Findings of Fact | Wetland Conditional Use Permit

City of Portsmouth Planning Board

Property Address: 50 Odiorne Point Road

Re: Restoration Plan
Gardner Property: Stone Wall, Swale, and Vegetation Restoration Project
Portsmouth, New Hampshire

PROPOSED RESTORATION AREAS AND EROSION AND SEDIMENT CONTROLS

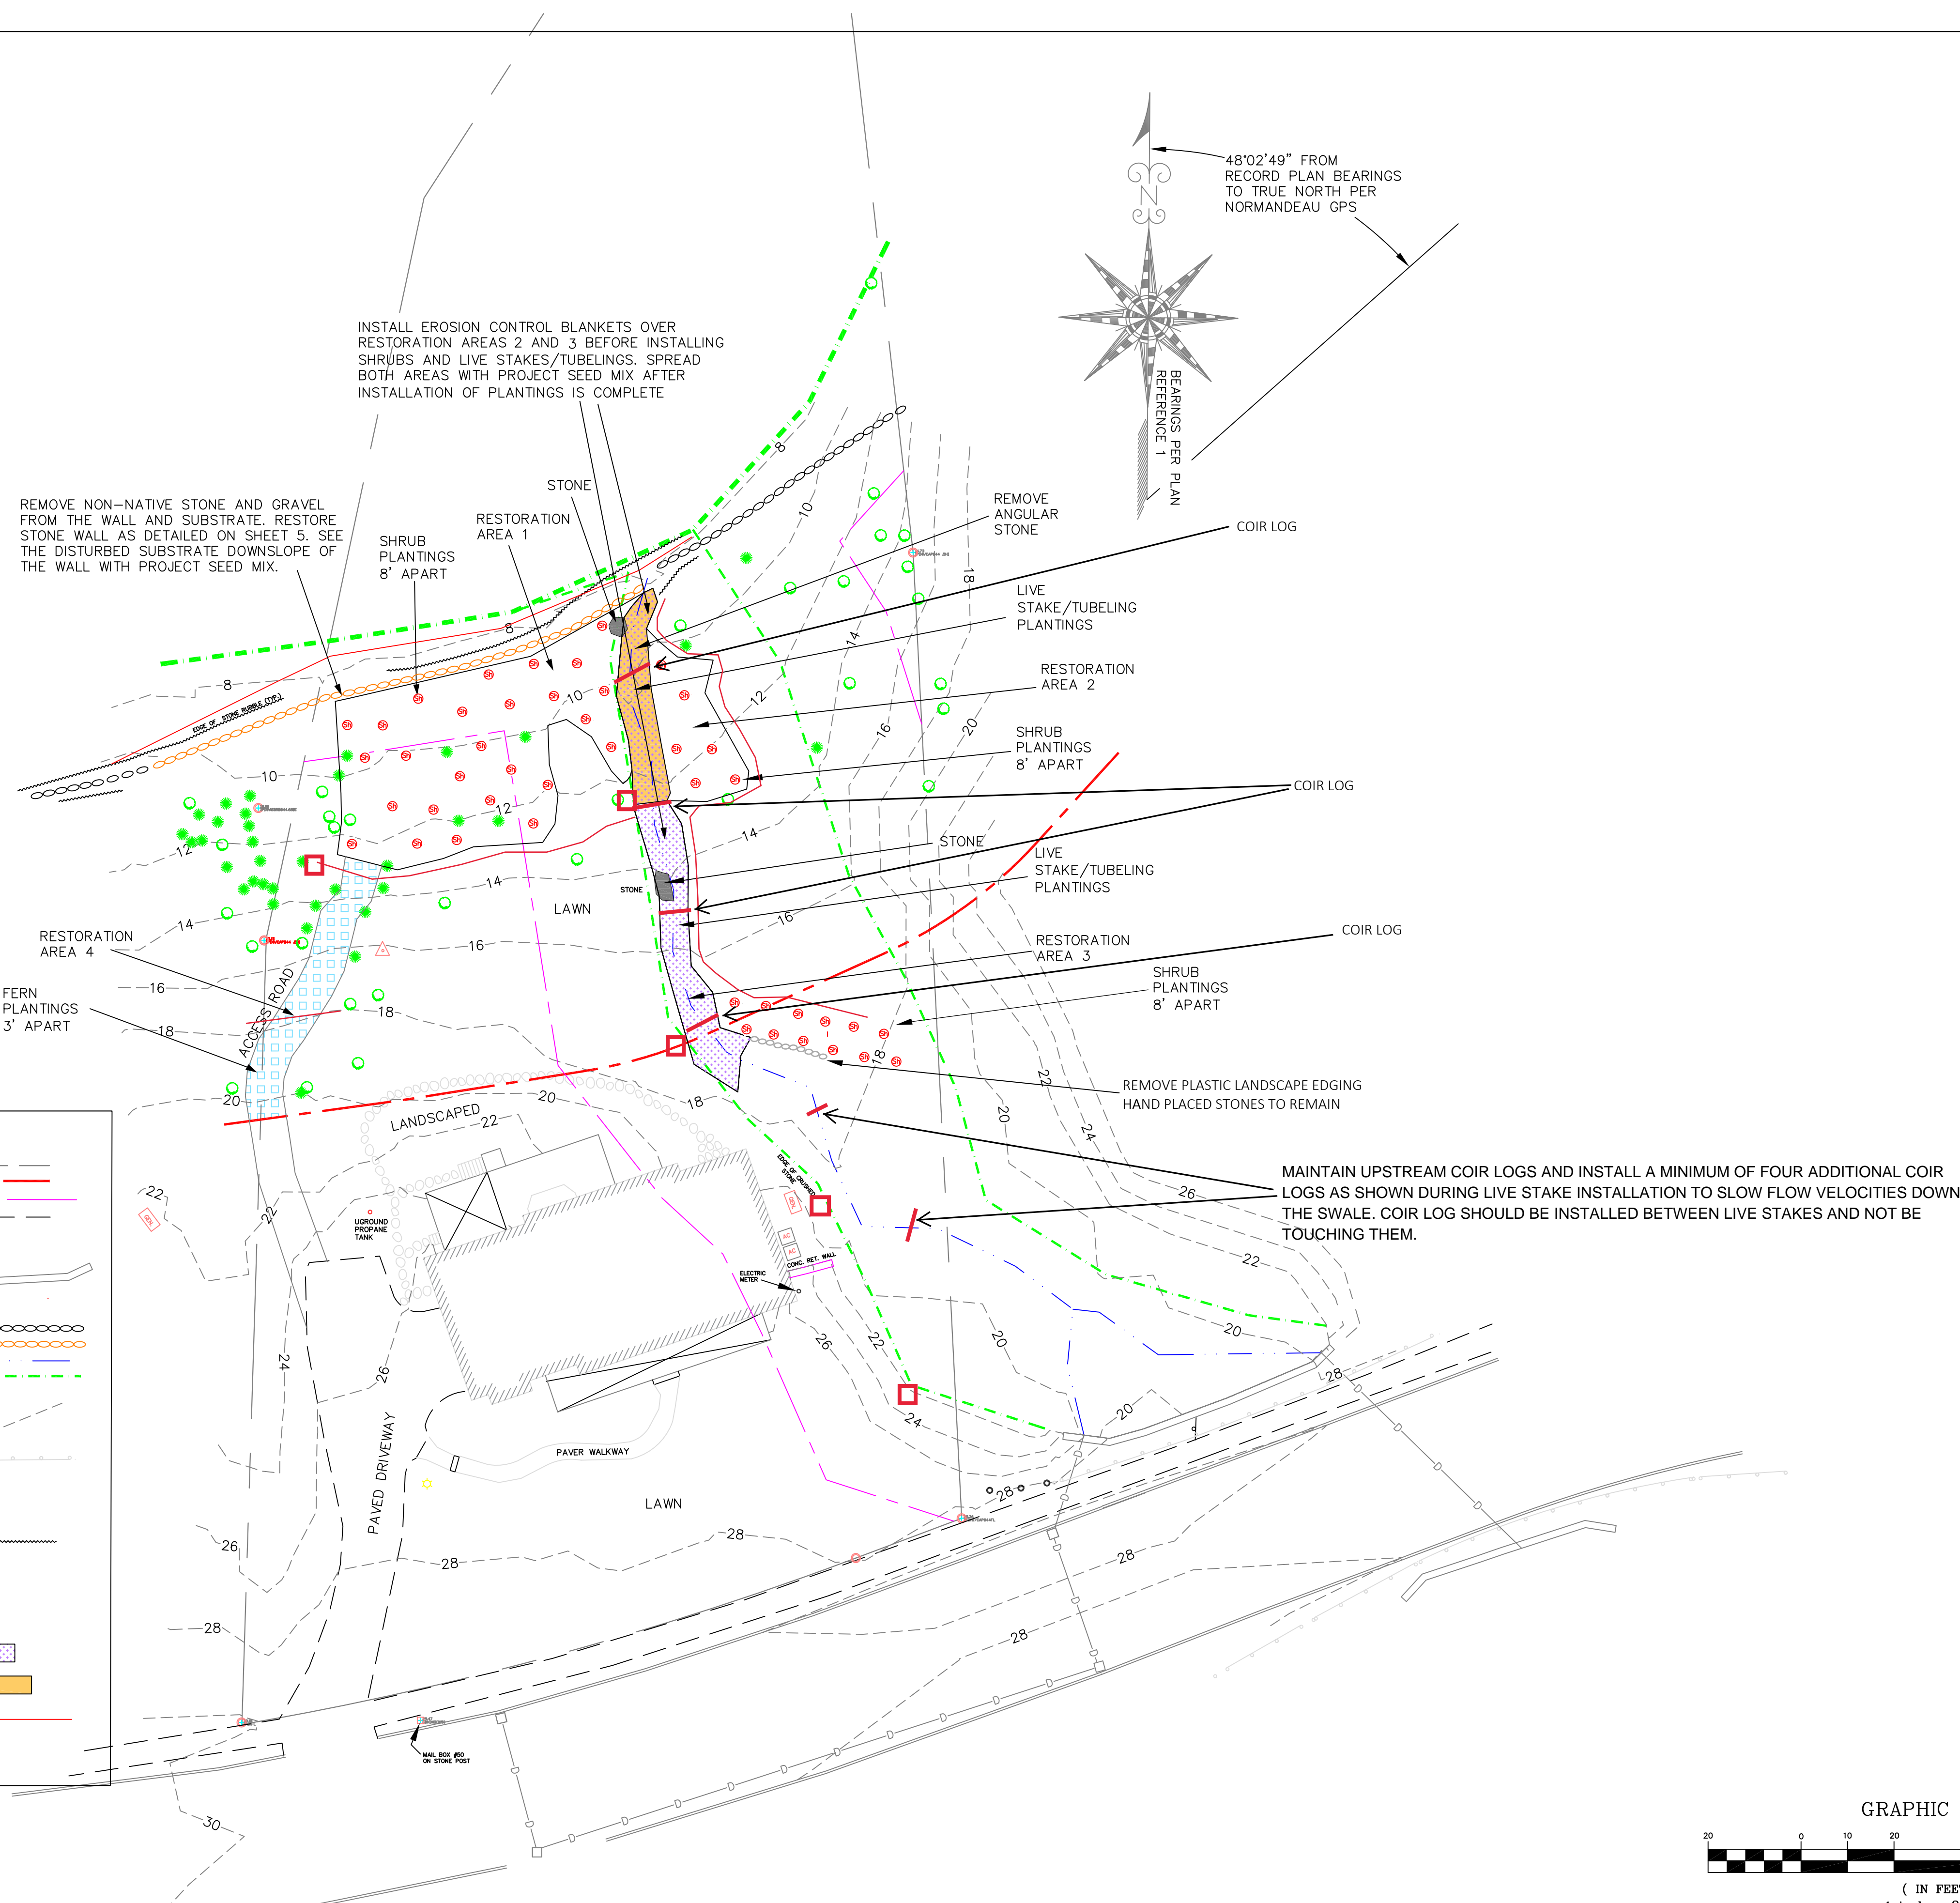
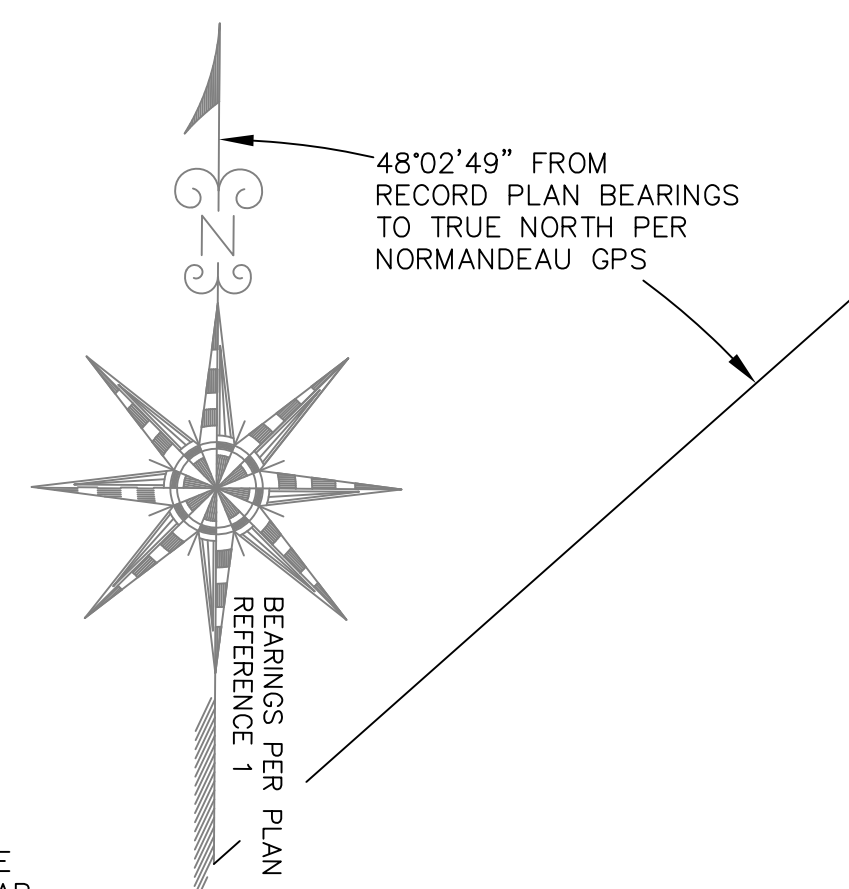
1. *The restoration plan shall be amended to include the addition of coir logs to protect the live stakes in the plant establishment phase.*

REVISIONS:
 ADDITION OF COIR LOGS ACROSS THE CHANNEL OF THE SWALE TO REDUCE FLOW VELOCITIES DURING LIVES STAKE ESTABLISHMENT PER STRIPULATION #1 OF THE PORTSMOUTH CONSERVATION COMMISSION DECISION LETTER. (02/21/24)

Project response: The project scope has been revised to include the installation of a minimum of six (6) coir logs across the existing channel of the swale as shown on Sheets 2 and 3 in Attachment B. Two of these coir logs will be installed during site set up to reduce flow velocities upstream of the restoration project, while the other four will be installed at intervals down the swale as stone is removed and live stakes installed. Coir logs will be positioned between live stakes with sufficient space to prevent them from pressing up against or touching the live stakes. All coir logs will be held in place using crossed wooden stakes rather than staking through the coir log itself, to maintain the integrity of the coir log. These coir logs will remain in place during live stake establishment and only be removed with the approval of Environmental Monitor for the project.

TYPICAL EROSION CONTROL BLANKET INSTALLATION

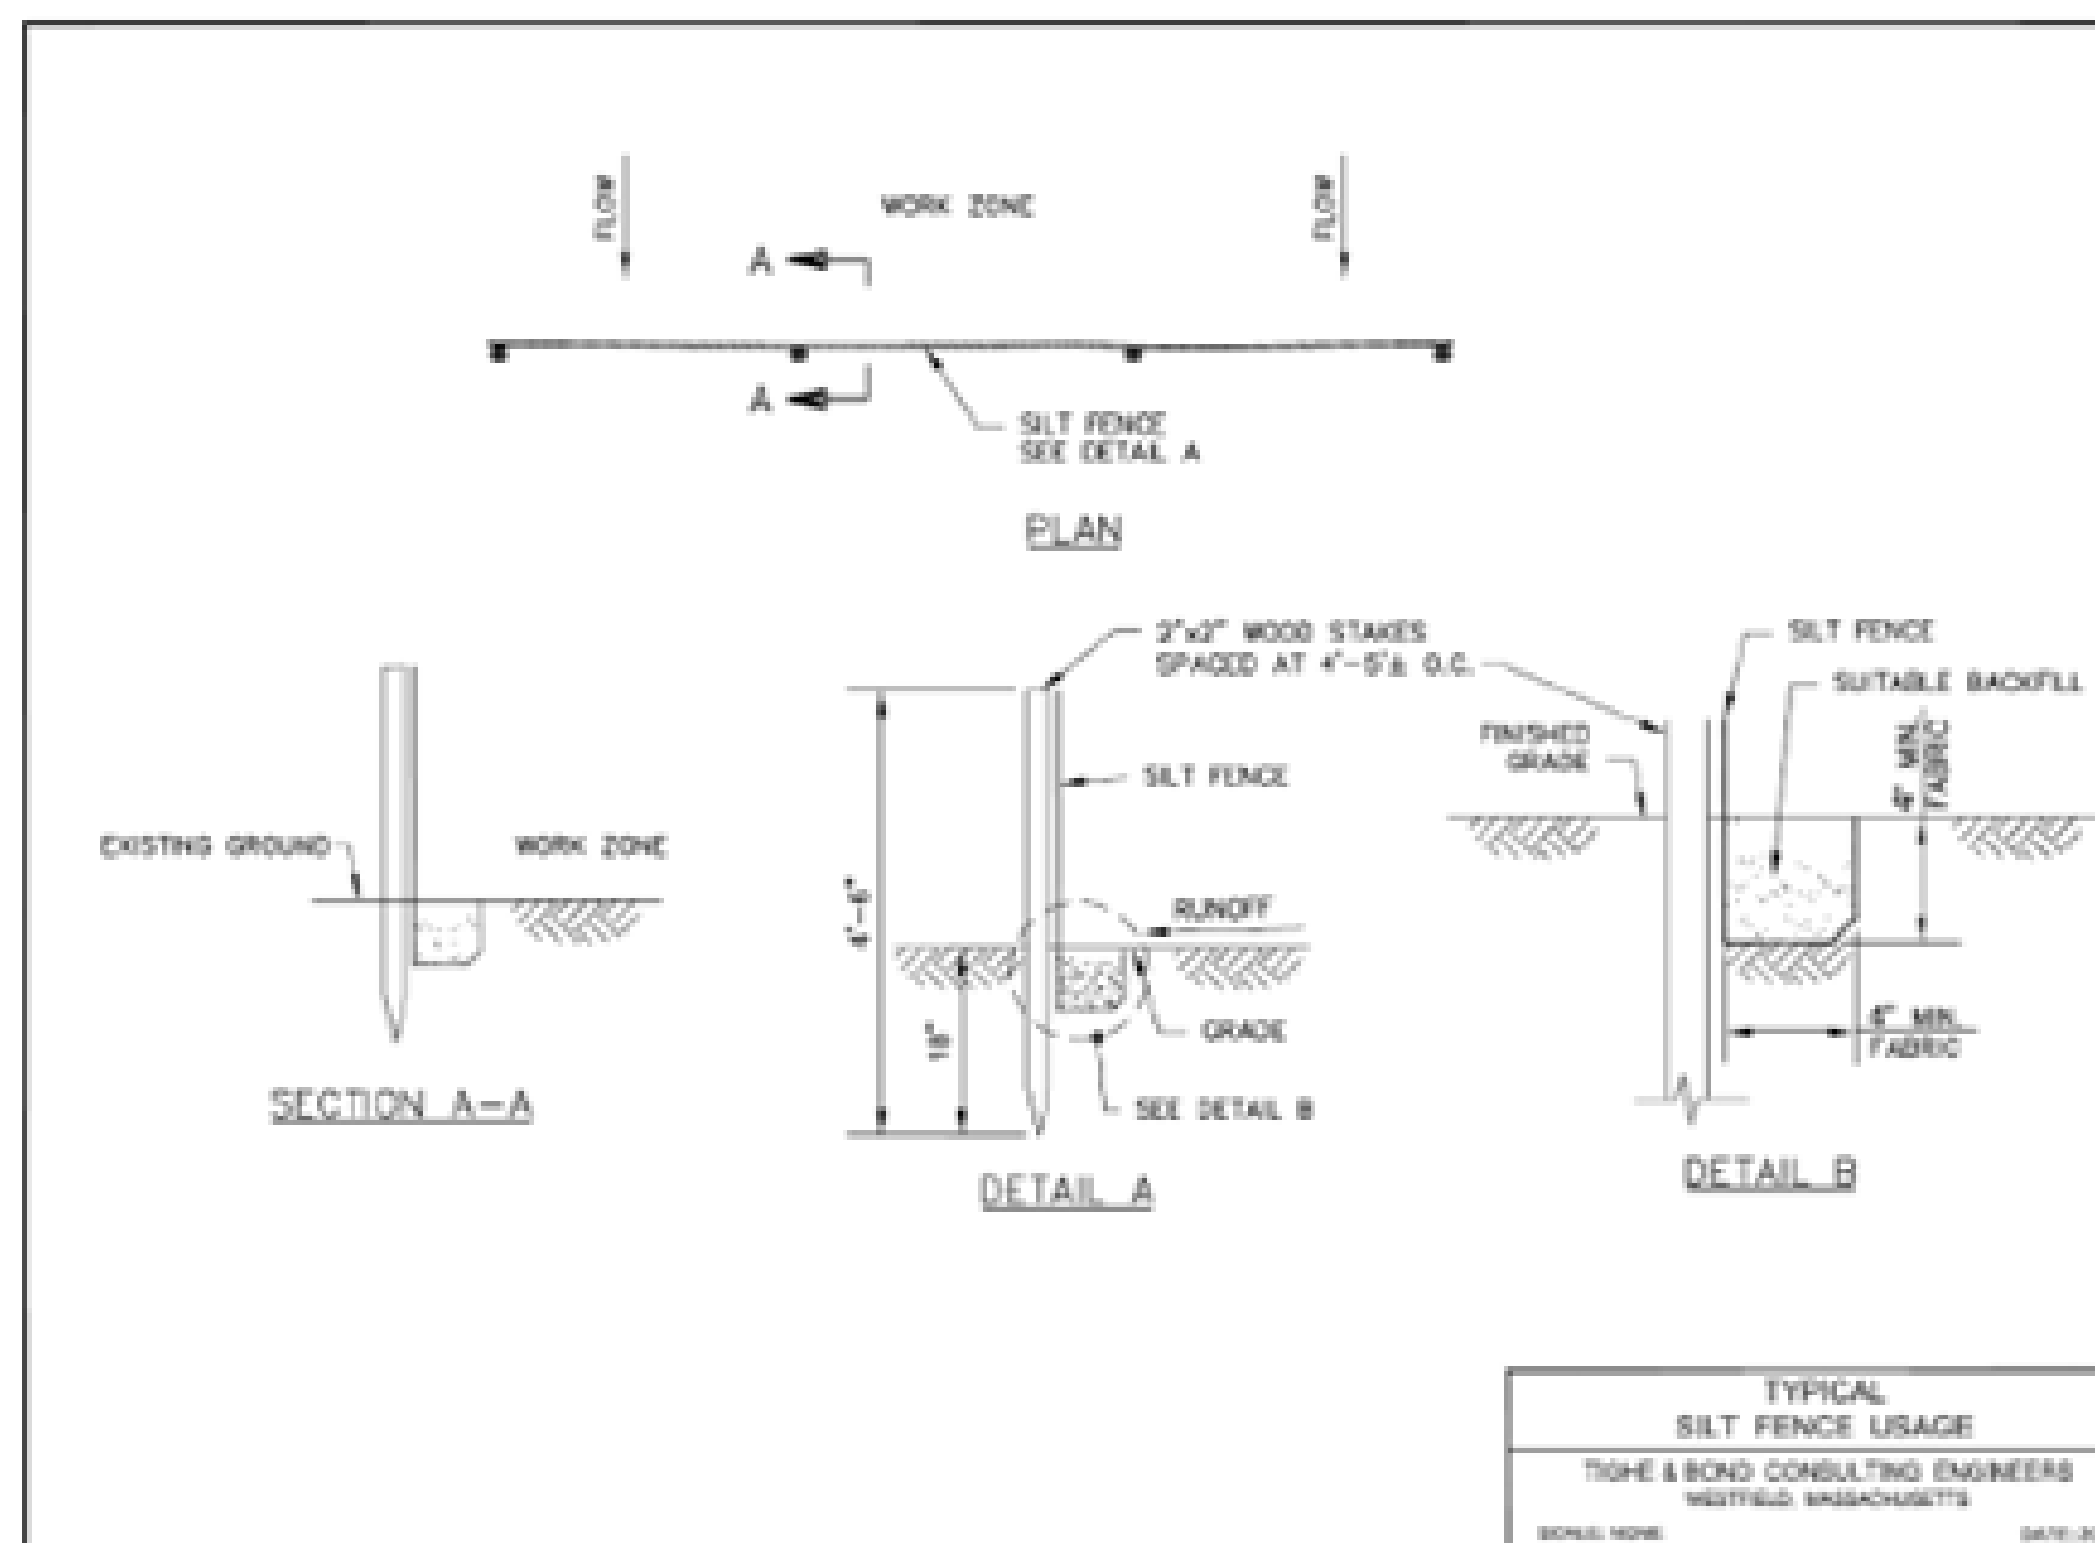
PLEASE NOTE: INSTALLATION OF COIR LOGS ACROSS THE STREAM CHANNEL UPSTREAM AND AT INTERVALS DOWN THE RESTORED SWALE HAVE BEEN ADDED TO THE SCOPE FOLLOWING REVIEW OF THE PROJECT BY THE PORTSMOUTH CONSERVATION COMMISSION ON FEBRUARY 14, 2024 FOR THE PURPOSE OF REDUCING FLOW VELOCITIES DOWN THE SWALE TO PROTECT THE LIVE STAKES/TUBELINGS DURING ESTABLISHMENT. WHILE COIR LOGS ARE SIMILAR IN SOME RESPECTS TO FILTER SOCKS, THEY SHOULD BE HELD IN PLACE WITH CROSSING WOODEN STAKES, RATHER THAN PLACING THE STAKE THROUGH THE COIR LOG TO BETTER MAINTAIN IT'S INTEGRITY.
